Annex J Holgate Ward

Location Springfield Avenue/Beech Avenue

J1

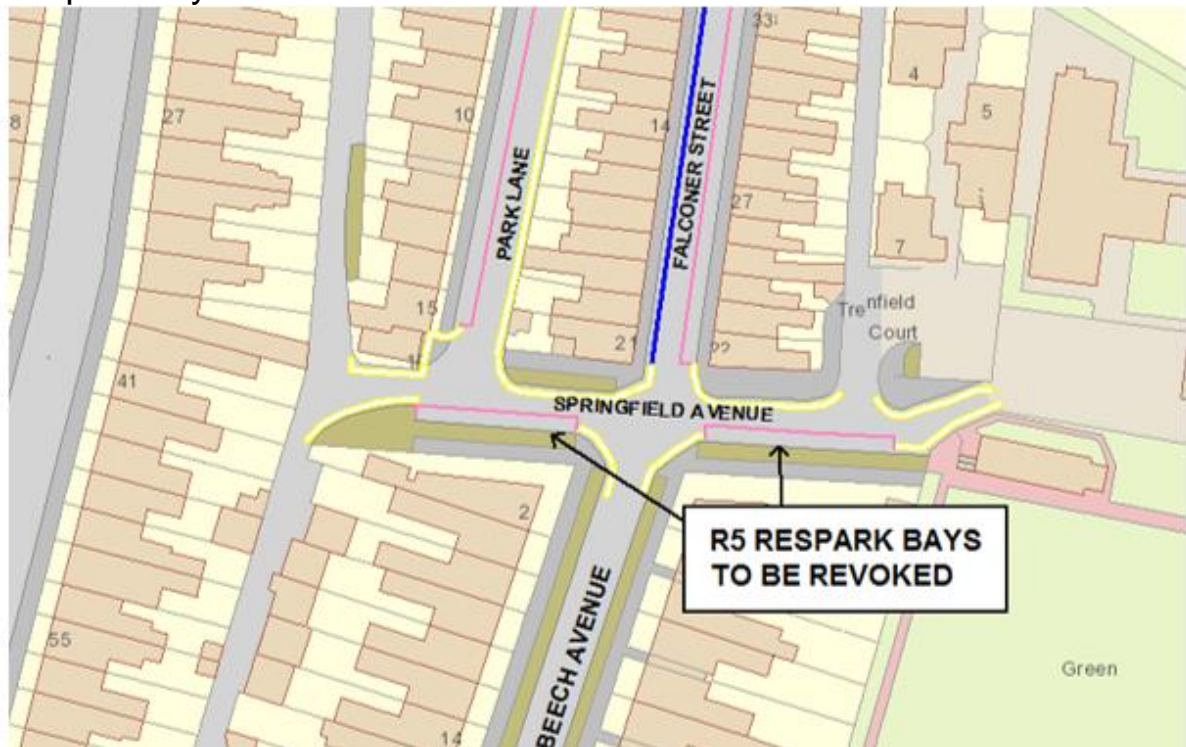
Residents raised an issue via a local ward Councillor regarding their inability to park on Beech Avenue due to residents of the neighbouring R5 Respark Zone parking on Beech Avenue free of permit charges and leading residents of the northern end of Beech Avenue parking on Springfield Avenue, and receiving PCN's for parking within the R5 Respark bays

We received two representations in support and one in objection to the proposal.

- I am in favour of the removal of the parking restrictions as long as the next ones are Park Lane and Falconer Street removal, as well. If this is being done then please remove them from Park Lane and Falconer Street as it then becomes a free for all with multiple occupancies. There's isn't enough parking need green areas. Turned into bays to help with the parking issues.

- In response to the letter received today detailing the proposed removal of the R5 parking bays on Springfield Avenue I wish to write in confirming my support of the proposal.

- I am emailing to voice my rejection and condemnation of the amendments included in the proposed traffic regulation order. Especially those that relate to the R5 parking bays on Springfield Avenue. I am a homeowner and resident of Falconer Street and parking for residents is already deeply unsatisfactory and by removing residential parking along Springfield Avenue it opens up the possibility of non-residents and tourists alike, parking there to visit nearby amenities like the allotments, bowling green and the Fox pub (and more).

The two bays are outside of properties that are not eligible to apply for permits to park in them and this is pushing parking issues on to Beech Avenue. On-site inspections of the area the bays have not been fully utilised, it is therefore recommended that the proposal is implemented as advertised.

J3**Location** Acomb Road**Nature of problem and plan of Advertised Proposal**

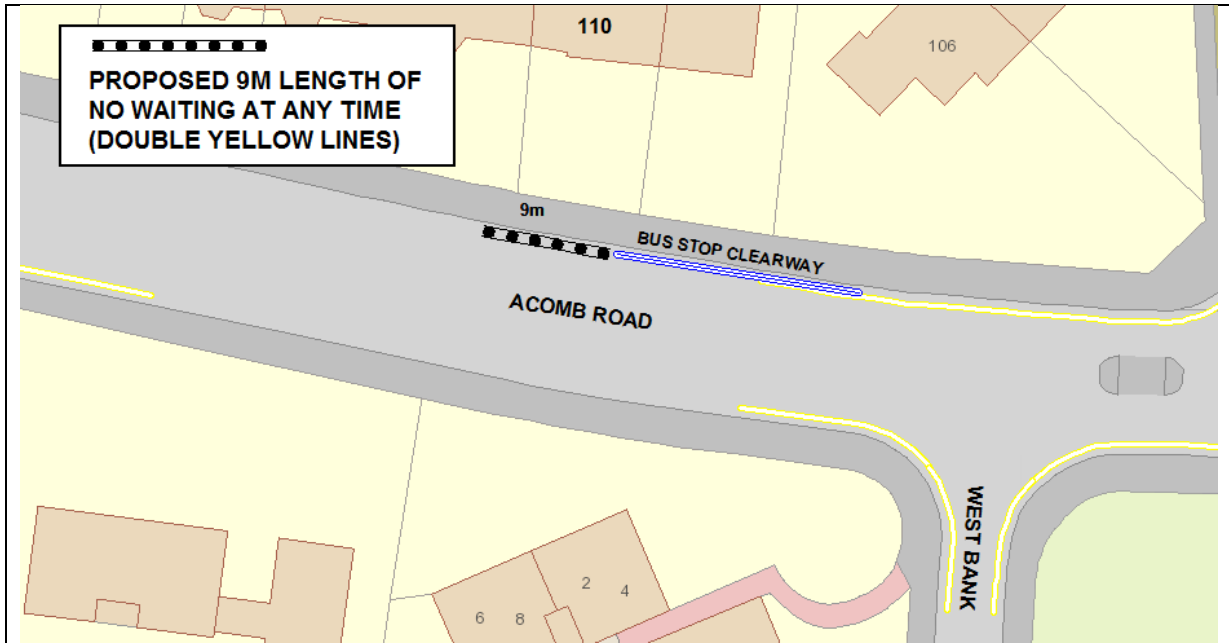
- I would like to object to the parking restrictions near 110 Acomb Road because it will reduce parking for local residents. Parking is already problematic due to the conversion on 126 and 128 Acomb Road into flats.
- I would like to strongly oppose these restrictions as they directly impact my business at 112 Acomb Road.

I recognise that 110 Acomb Road had an issue once when a car parked across their driveway and think double yellow lines there would be a reasonable idea to protect access to their driveway, but I see no benefit in extending the restriction in front of my own property at 112.

Perhaps you could consider extending the restrictions adjacent to the bus stop on the south side of the road. There are fewer residences and businesses on that side of Acomb Road and flats on that side have their own parking. If you limit parking on the north side, many residents will have to carry their children, shopping, etc across the busy road, deliveries and tradesmen will be affected and it is altogether an unhelpful change to a greater number of businesses and homes.

- Parking along this stretch of Acomb Road has become much more difficult since the planning applications for conversion of the two corner properties (Acomb Road / Braeside Gardens) were enacted last year, creating numerous flats with limited parking of their own. There is no obstruction to visibility splays due to parked cars on the stretch of road outside our property.

I have no objection to the no waiting being implemented outside 110 Acomb Road, but object strongly to a reduction in ability to park outside our own home.

Incidentally, I also mentioned earlier that the Bus Stop Clearway, now physically marked on the roadway on the North side of the road opposite our property, is missing from your map. In order to improve visibility and traffic flow at the junction with West Bank, especially during morning rush hour, it would actually make more sense to introduce double yellow lines on the North side of Acomb Road, running from the "missing" Bus Stop Clearway to West Bank. There are no properties fronting Acomb Road at that point, but when cars park there it does occasionally cause obstruction to the flow of traffic.

Having a restriction in the approach to the bus clearway will serve to protect the ability to enter the filter lane for West Bank and provide access to the bus clearway (plan below).
